Customer Satisfaction Program

26180 Incorrect Value Indicated for Trunk Release Fuse

Reference Number: N15202618

Release Date: December 2016
Revision: 01

4623947

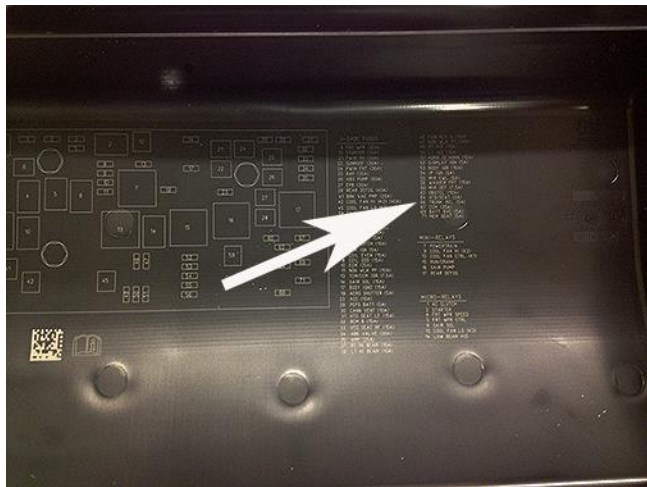
2. Verify that the fuse value for the fuse in location F66 (Trunk Release) is 5 Amp. If the fuse value is not correct, replace the fuse with the proper fuse.

4623926

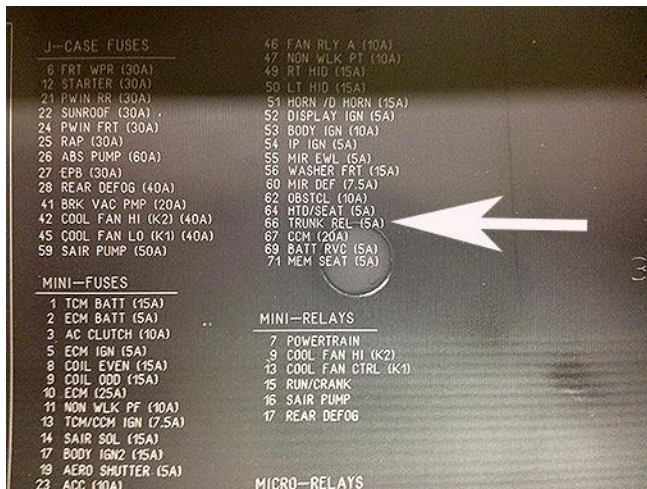
- Inspect the front compartment fuse block cover. Verify that the fuse value for location F66 (Trunk Release) is 5 Amp.

- If the value is correct (5 Amp), no further action is required.
- If the value is not correct (10 Amp), replace the fuse block cover as follows:

- Locate the engine compartment fuse block part number, located on the front edge of the assembly (1).
- Record the part number.
- Install the correct replacement cover using the information in the part table above.
